Bayside Planning Panel

Item No	5.2
Application Type	Development Application
Application Number	S82-2017/8
Lodgement Date	16 June 2017
Property	40A Stoney Creek Road Bexley
Owner	Mr T Younnan
Applicant	Mr T Younnan
Proposal	Review of Determination - Adaptive reuse and additions and alterations including first floor to convert to residential dwelling.
No. of Submissions	Nil
Cost of Development	\$80 000
Report by	Fiona Prodromou, Senior Assessment Planner

Planning Assessment Report

Application Number:	S82-2017/8
Date of Receipt:	16 June 2017
Property:	40 A Stoney Creek Road, BEXLEY (Lot 1 DP 713595)
Owner(s):	Ms Hannan Abi-Raad Mr Tony Manuel Younan
Applicant:	Mr Tony Younan
Proposal:	Review of Determination - Adaptive reuse and additions and alterations including first floor to convert to residential dwelling
Recommendation:	Refused
No. of submissions:	Nil
Author:	Fiona Prodromou
Date of Report:	11 October 2017

SOUTH ELEVATION

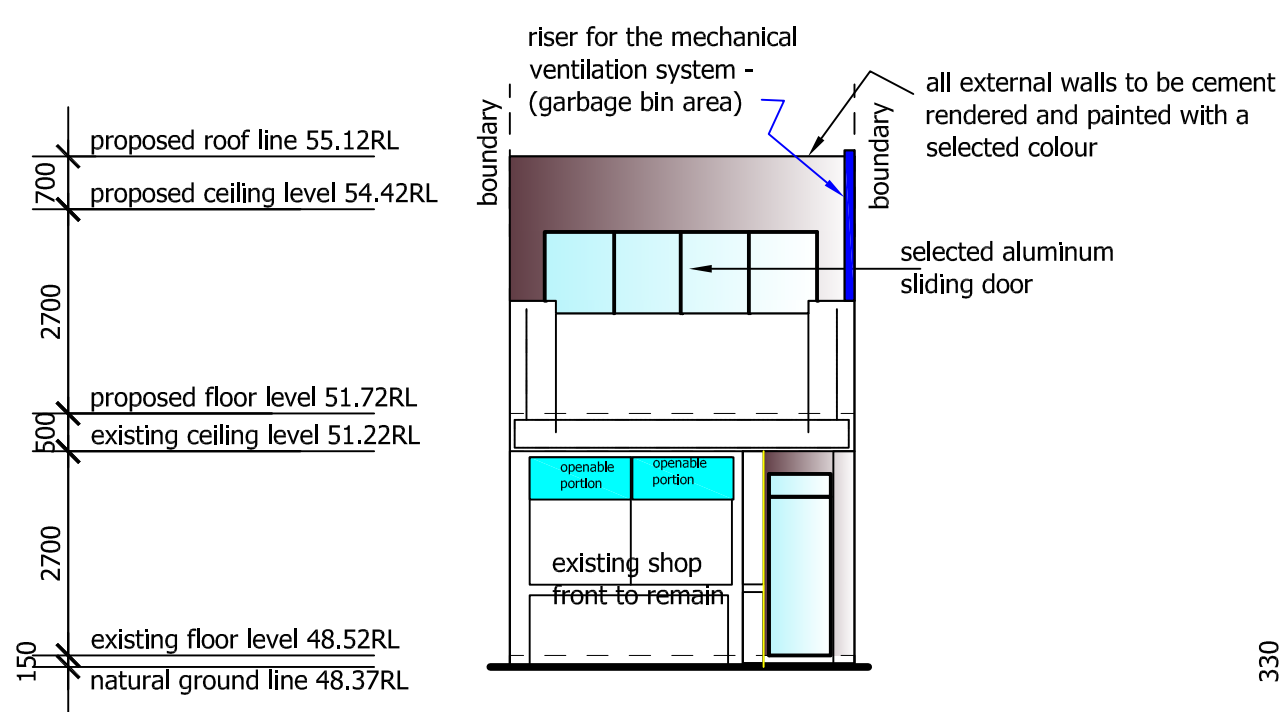
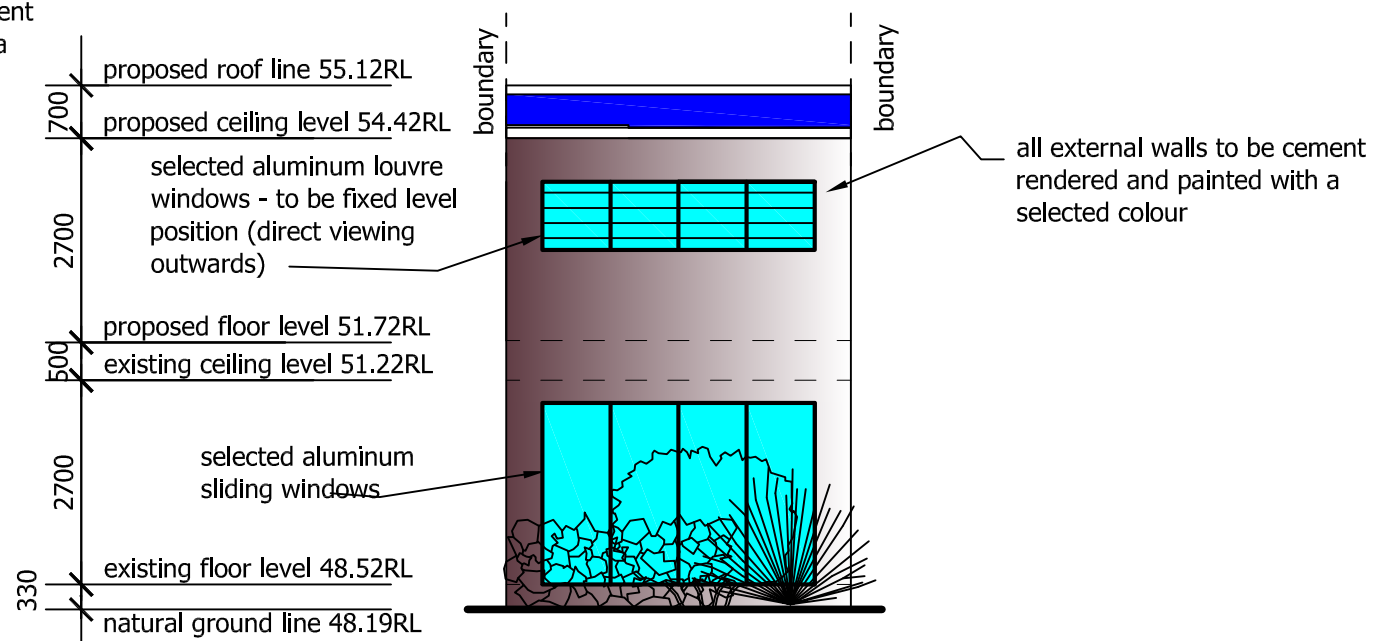
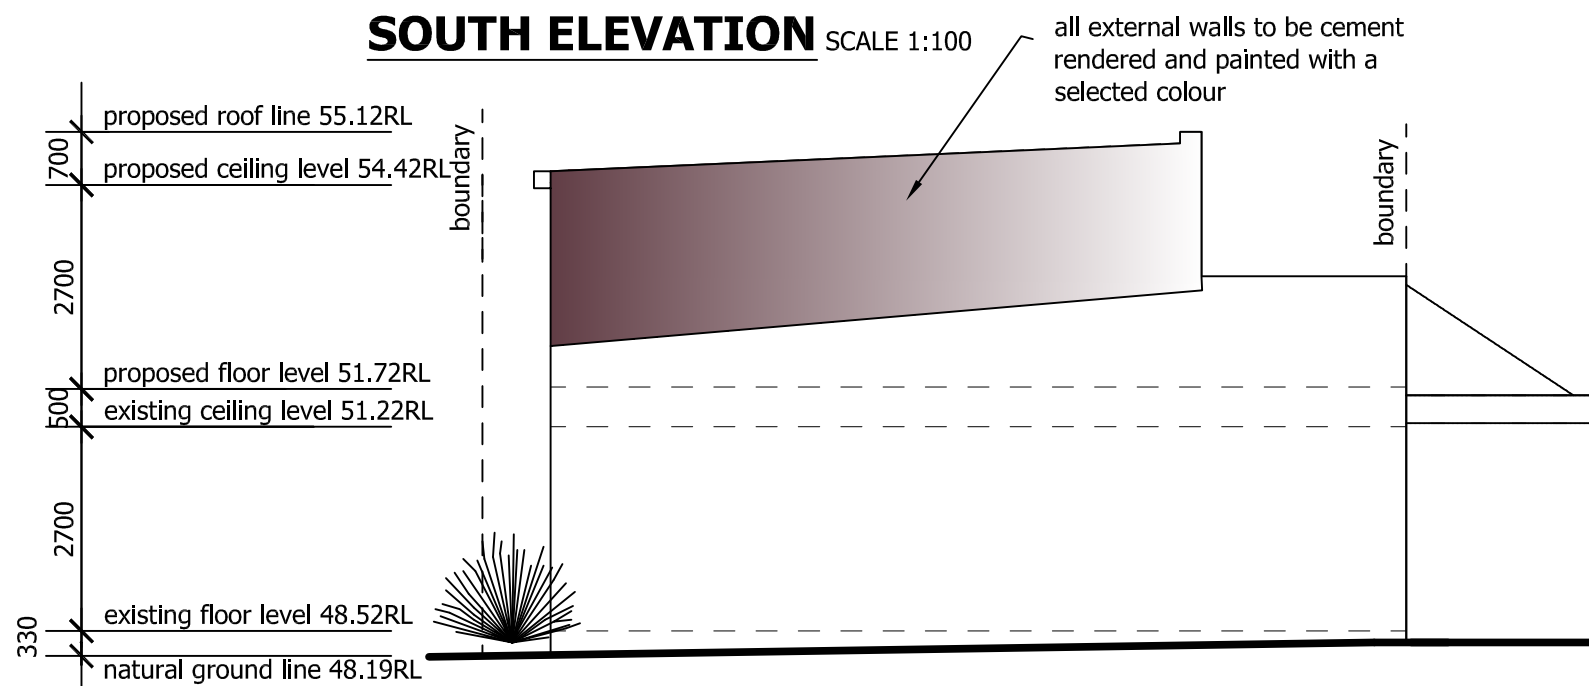
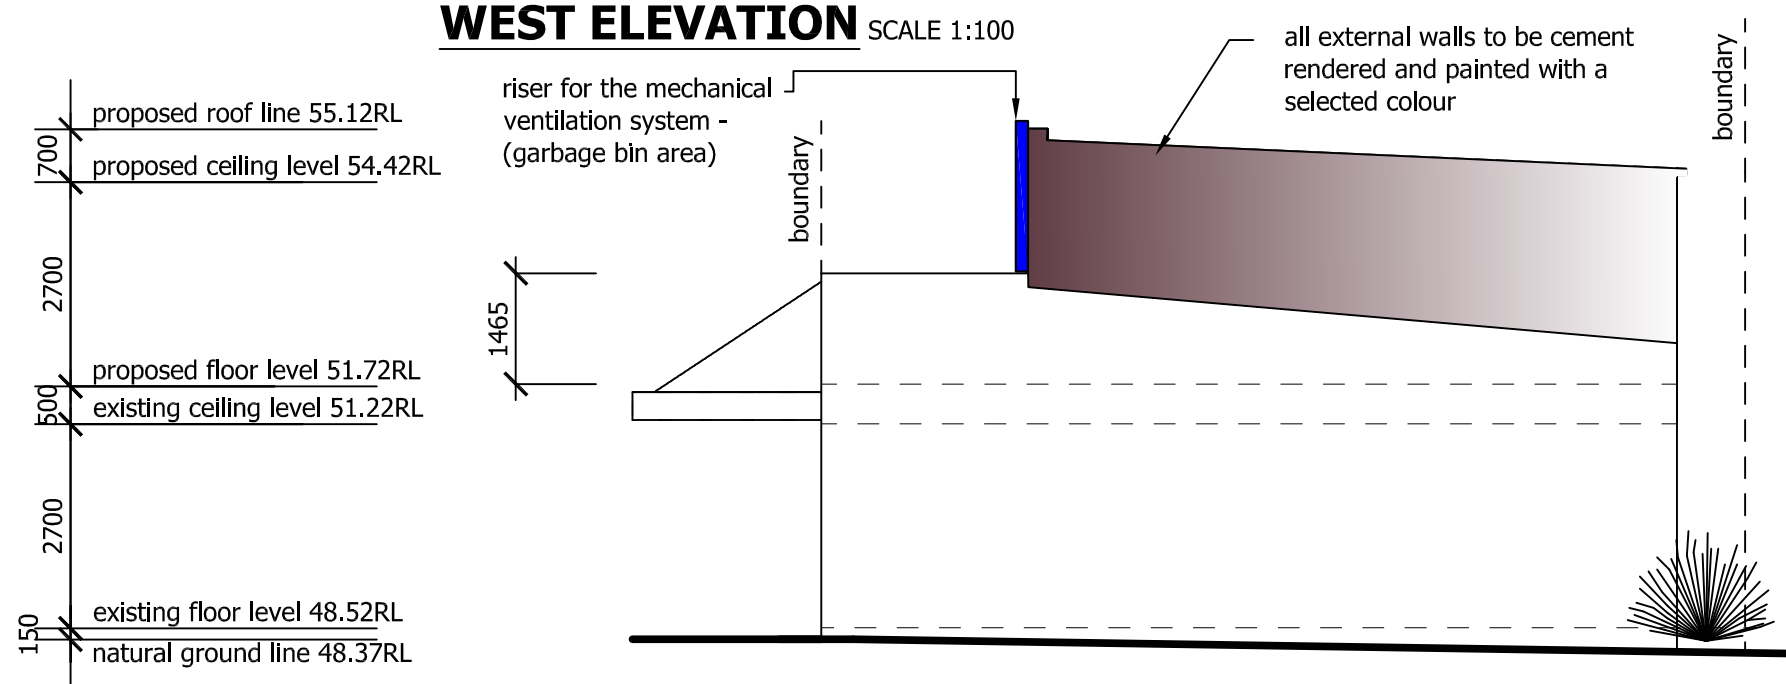
- a) SEE states the proposal seeks to *"remove an existing awning that extends over the footpath"*.
- b) Plans are inconsistent with (a) above and illustrate the retention of the existing awning.
- c) Schedule of colours / finishes has not been submitted for review.
- d) Details in relation to proposed planting and levels within the rear 0.9m setback as proposed have not been submitted for assessment. It is unclear how this proposed landscaped area is to be maintained.

PROPOSED OVERSHADOWING JUNE 21
@9AM, 12NOON AND 3PM SCALE 1:200

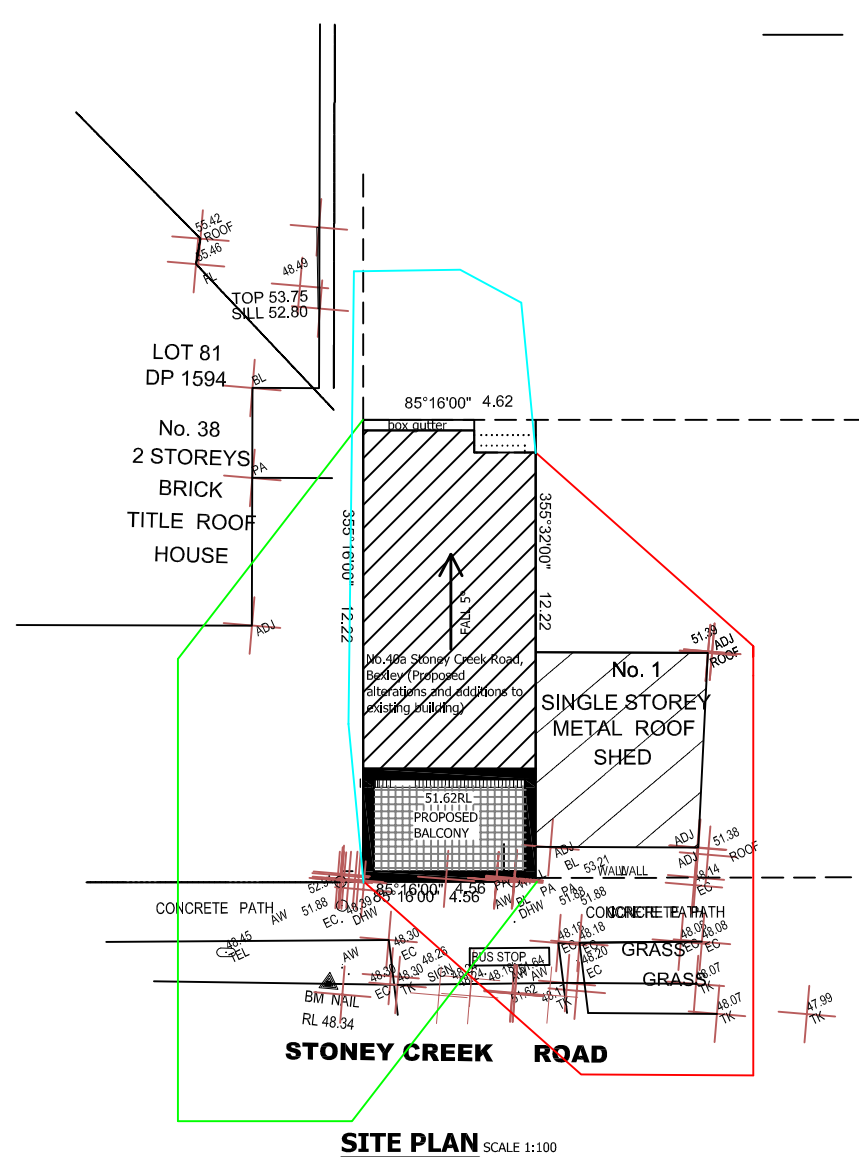
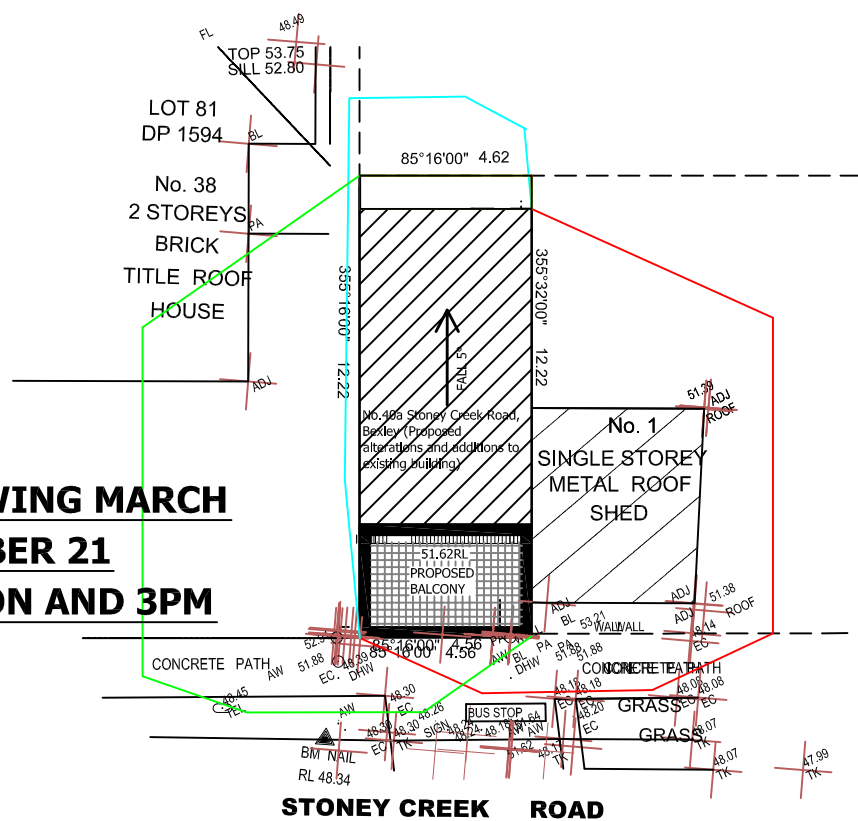
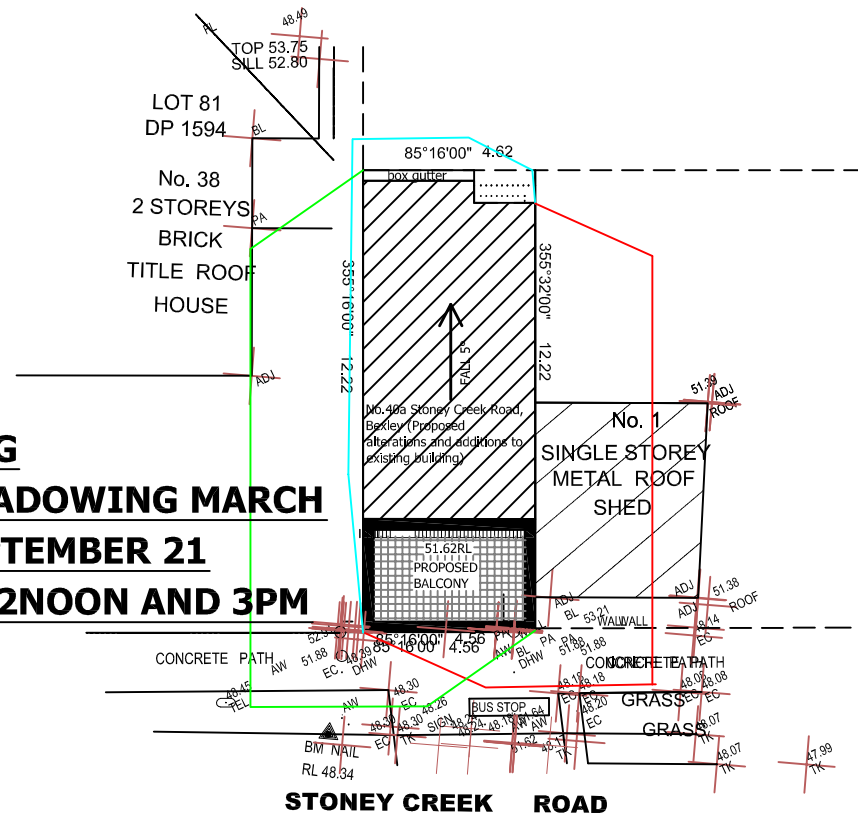
The first floor living area is oriented to the south, as is the private open space area, as previously discussed in this report. The applicant seeks to provide an operable skylight *'within the roof over the proposed lounge area. A closing device would be provided to that skylight so that it could be closed when desired. That skylight will allow solar penetration into the lounge area, and also onto the proposed balcony through the front windows'*.
